ADDENDUM NO. 03.1

SUBJECT: Addendum No. 03.1 – Public Safety Complex Construction

Project: 19018_COK Public Safety Complex
Date: 24 February 2021

Addendum 03.1 forms a part of Construction Documents and modifies the original drawings and specifications issued on February 1, 2021.

E201

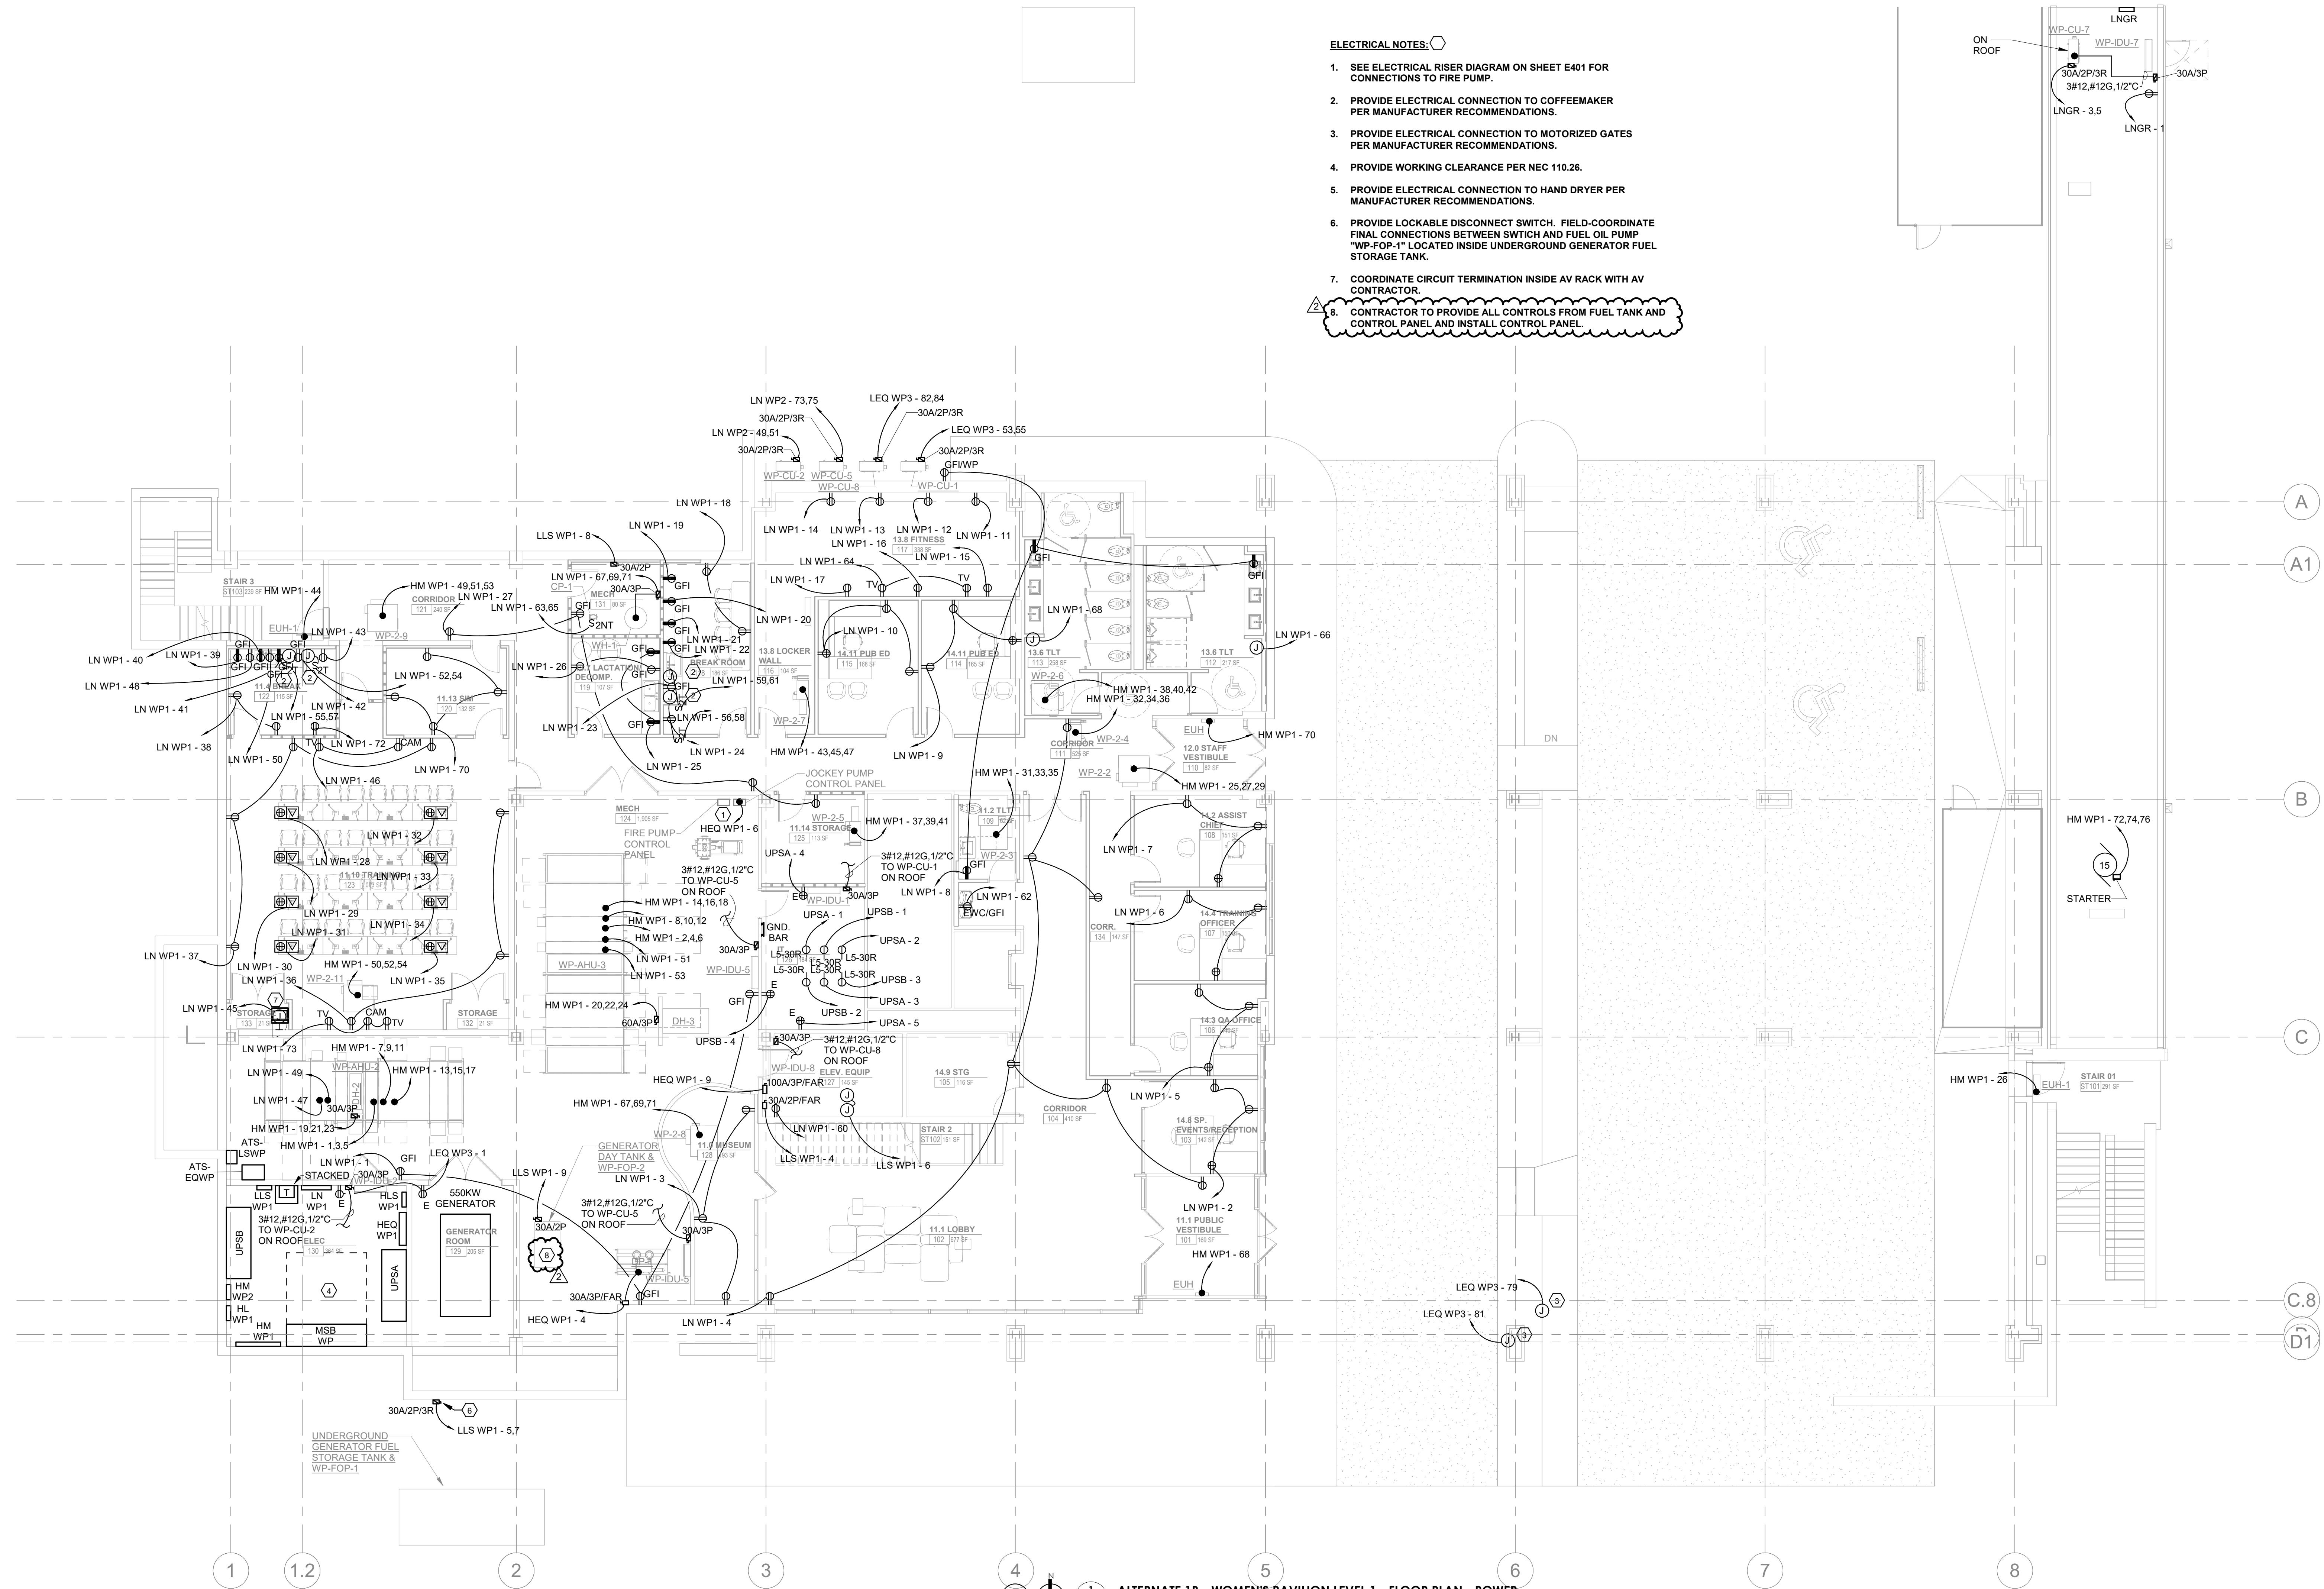
- On drawing E201 & E220.2 it shows the underground fuel tank for the gensets in areas that could be a problem to install relative to existing subgrade utilities. Has the location of the underground fuel tank locations been coordinated with subgrade conditions?
- **Location has been coordinated among the design team and are the preferred location.**
- Are there any conduits that the electrical will need to install for controls or electrical for the underground fuel tanks? Who installs the control panels?
- **Yes the electrical contractor is responsible for controls and control panel installation.**
- On the riser drawing for the POB the fire pump and the main distribution feeders are shown to be concrete encased in the garage area. Could the panel & pump be relocated for cost savings?

E220.2

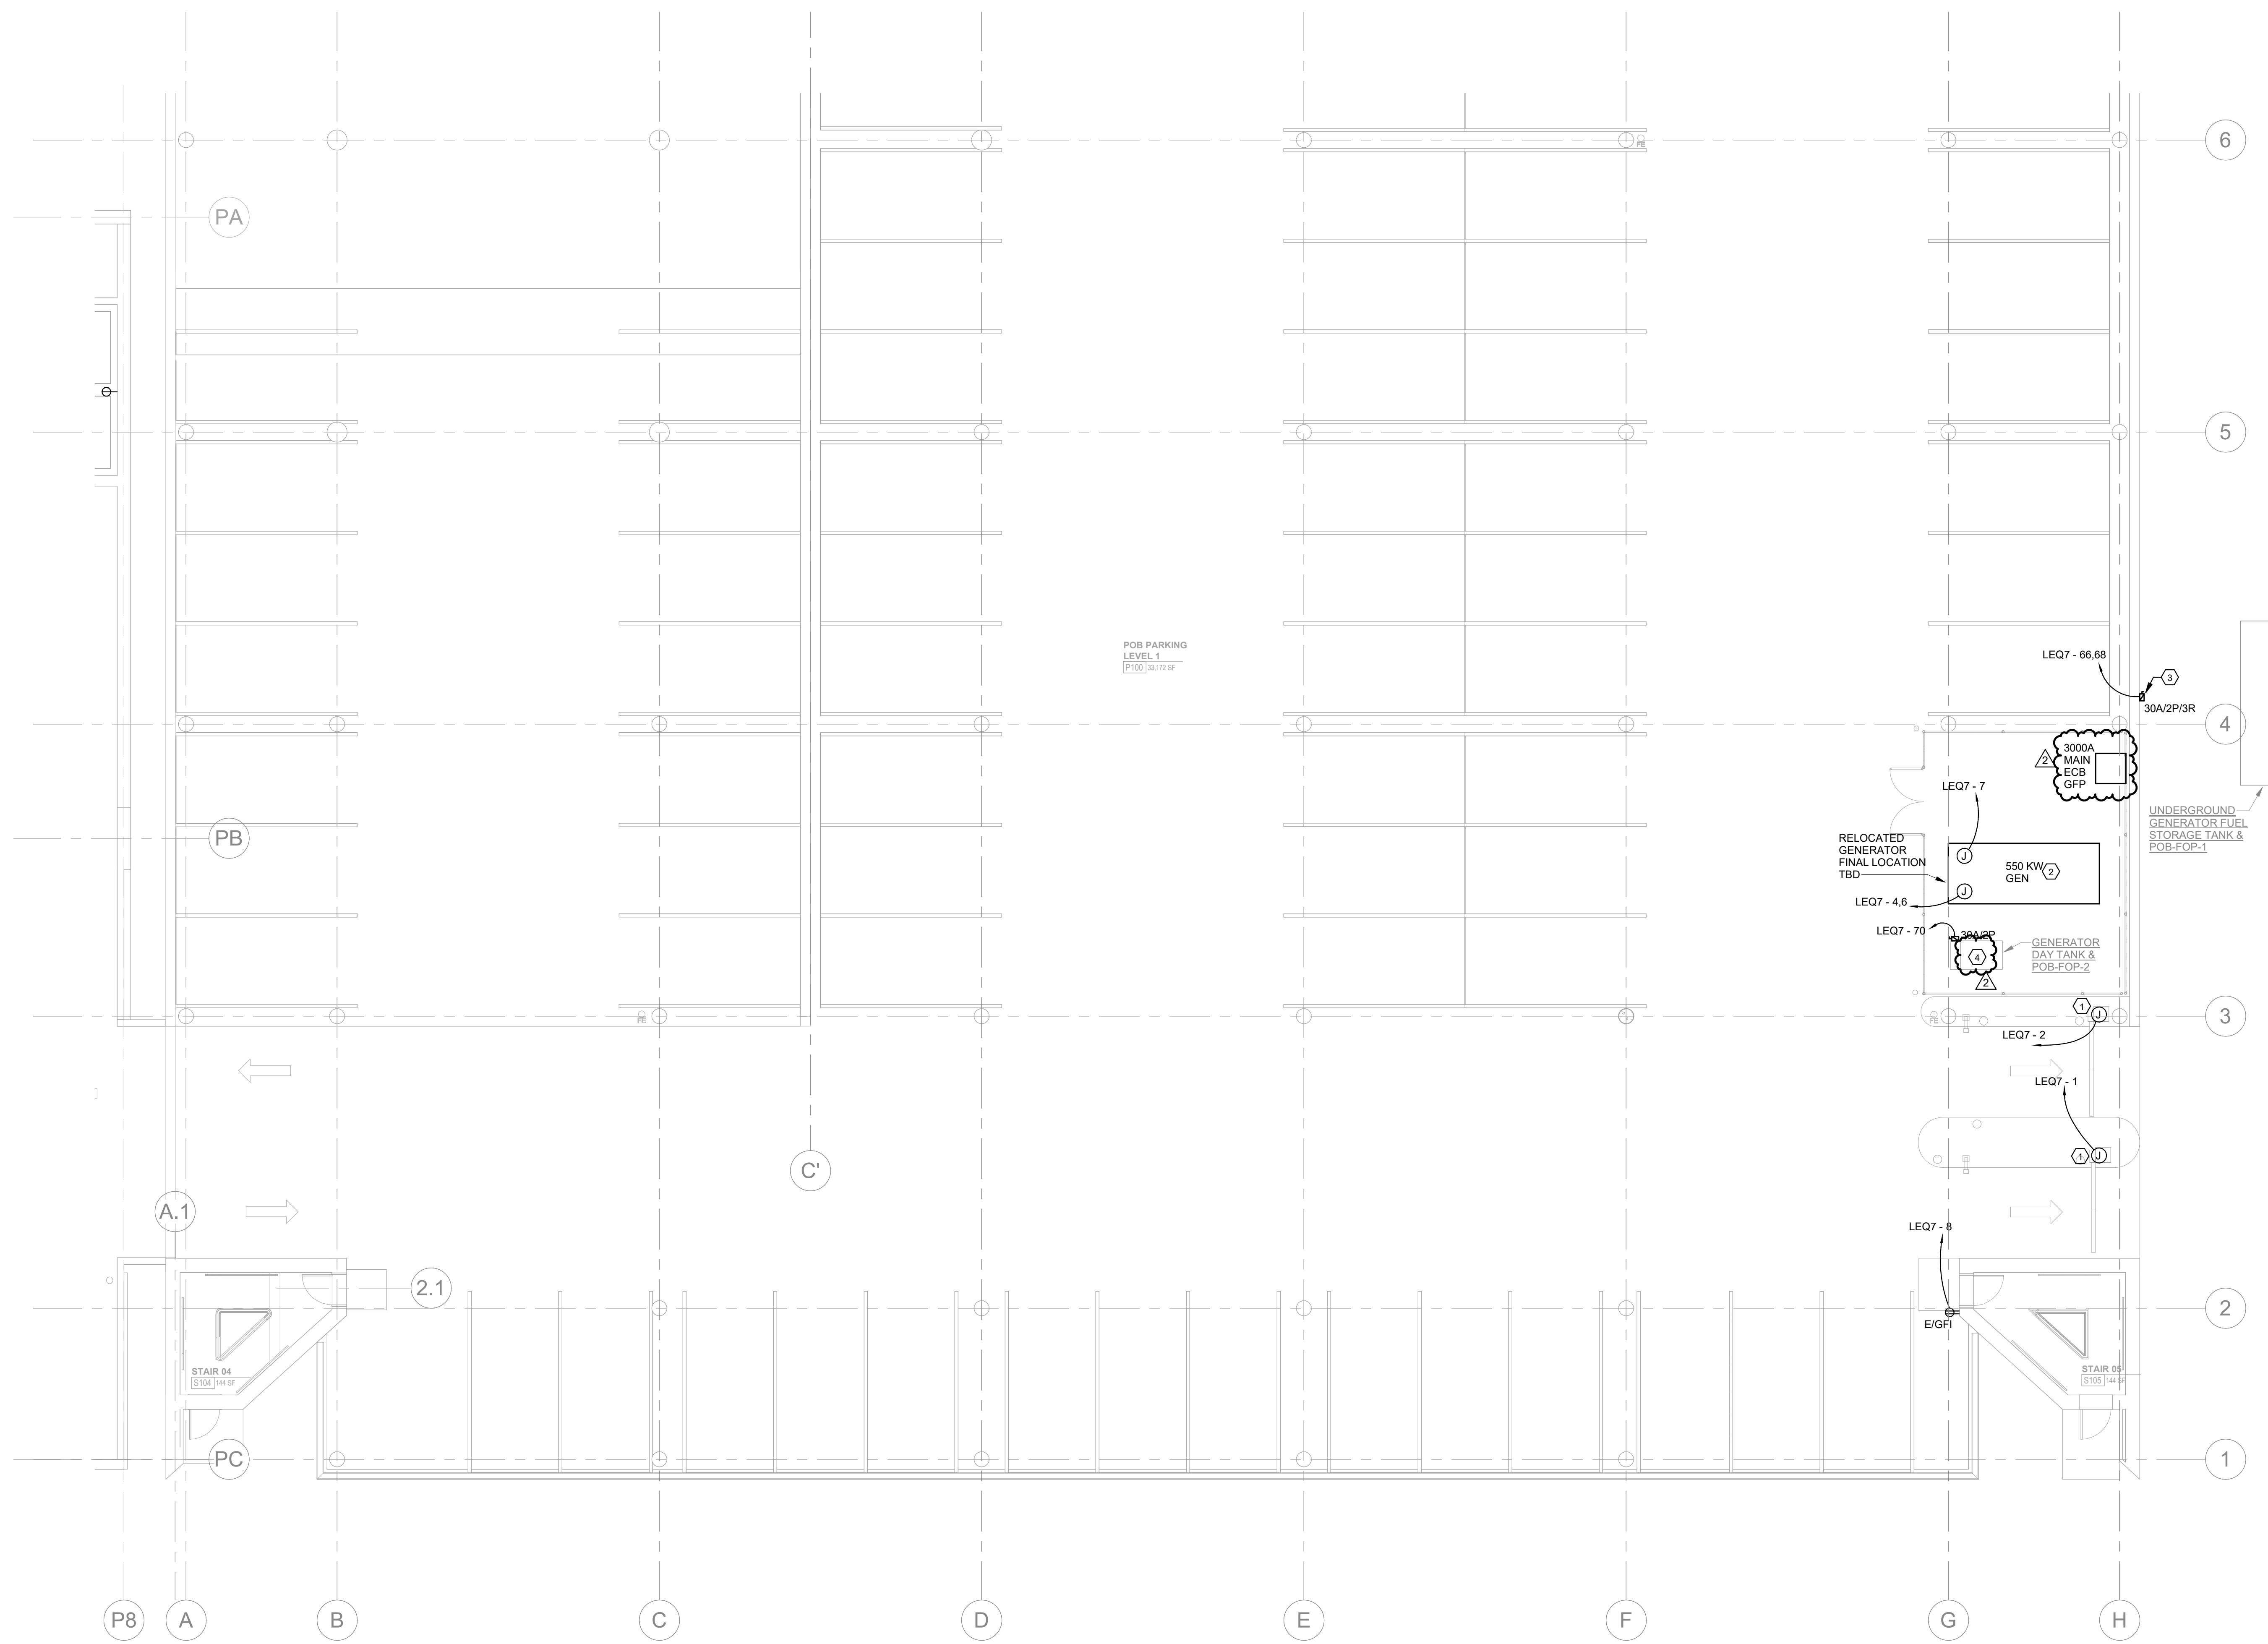
- Refer to revised Specification 07 25 00 Weather Barriers.**
84. On drawing E201 & E220.2 it shows the underground fuel tank for the gensets in areas that could be a problem to install. Need to confirm location?

- On drawing E220.2 note #2 calls out that the existing genset in the Clarke building should be sent to "CAT" for recertification. Which genset are they talking about? What should the recertification process include? Is "CAT" the only dealer we can use? Will the cost of recertification be paid by the GC or owner?
